RENESAS TECHNICAL UPDATE

Product Category	MPU/MCU		Document No.	TN-SY*-A0041A/E	Rev.	1.00
Title	Errata for User's Manual regarding the IIC		Information Category	Technical Notification		
Applicable Product	Renesas Synergy™ S3A7 MCU Group	Lot No. All	Reference Document	S3A7 Microcontroller Group User's Manual Rev.1.40

The specified Renesas Synergy S3A7 User's Manual has incorrect statements about the IIC.

Page 866 of 1517

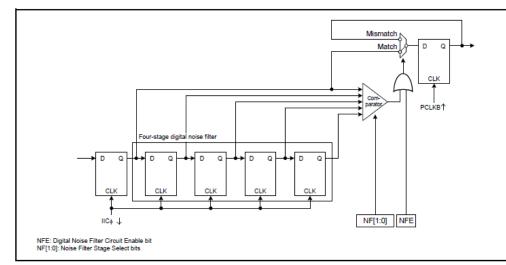
Incorrect

The IIC can also set the AL flag to indicate the detection of arbitration loss during NACK transmission in master mode or during data transmission in slave mode.

Correct

The IIC can also set the AL flag to indicate the detection of arbitration loss during NACK transmission in master mode or during data transmission in slave mode.

Page 891 of 1517

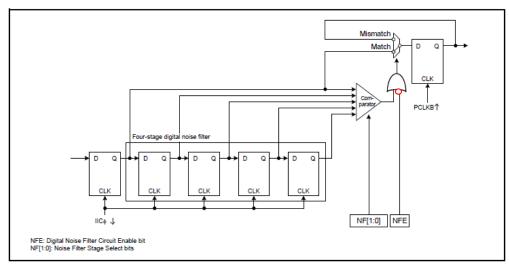
Incorrect Figure

Correct Figure

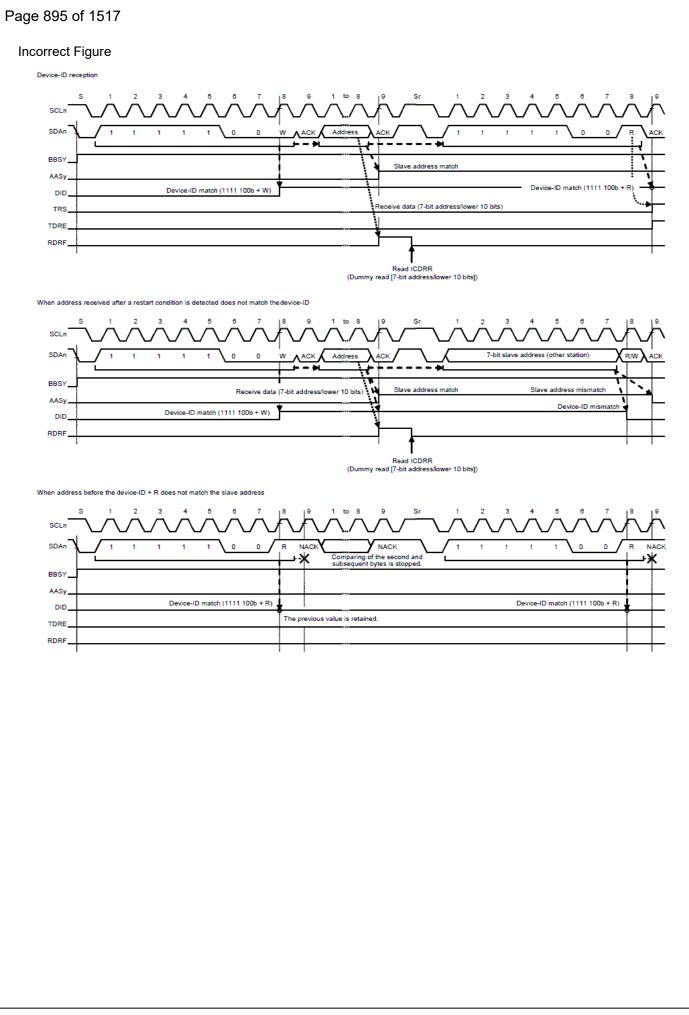
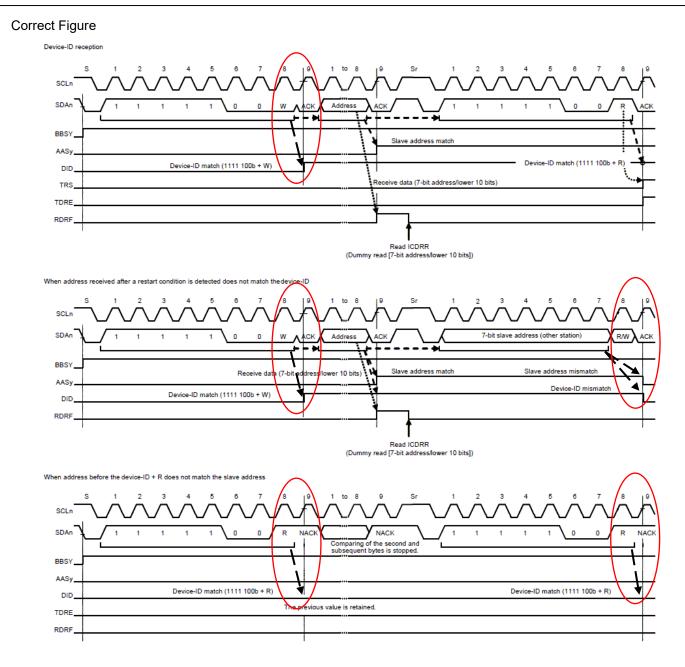
Page 907 of 1571 Incorrect Figure (7-bit address + W) [Slave transmit mode] Automatic low-hold (to prevent wrong transmission) Bus free time (ICBRL) 5 2 3 4 6 7 Data (DATA 1) 7-bit slave addres w Transfer su ended BBSY Address match AASy Transmit data (DATA 1) Transmit data (DATA 2) TRS TDRE NACKE Write data to ICDRT Write data to ICDRT Write 1 to SP bit Clear NACKF flag register (DATA 1) register (DATA 2) **Correct Figure** [Slave transmit mode] matic low-hold (to prevent wrong transmission) Bus free time (ICBRL) 2 3 2 3 4 5 6 F $\dot{}$ 7-bit slave address W ACK Data (DATA 1) Transfer su ended BBSY Address match AASy Transmit data (DATA 1) Transmit data (DATA 2 TRS TDRE NACKF Write 1 to SP bit Write data to ICDRT Write data to ICDRT Clear NACKF flag register (DATA 1) register (DATA 2)

Page 917 of 1517

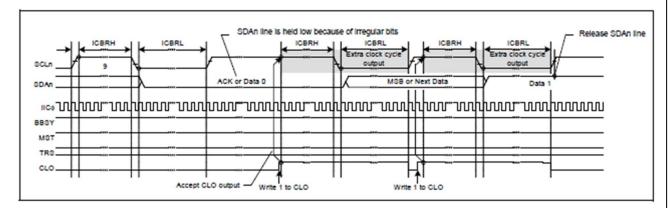
Incorrect

Use this function with the MALE bit in the ICFER register set to 0 (master arbitration-lost detection disabled). If the MALE bit is set to 1 (enabled), arbitration is lost when the value of the ICCR1.SDAO bit does not match the state of the SDAn line.

Correct

Use this function with the MALE bit in the ICFER register set to 0 (master arbitration lost detection disabled). If the MALE bit is set to 1 (enabled), arbitration is lost when the value of the ICCR1.SDAO bit does not match the state of the SDAn line.

Page 918 of 1517

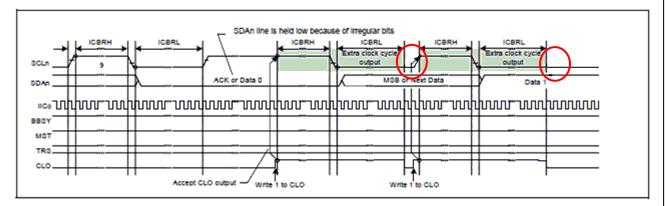
Incorrect Figure

Correct Figure
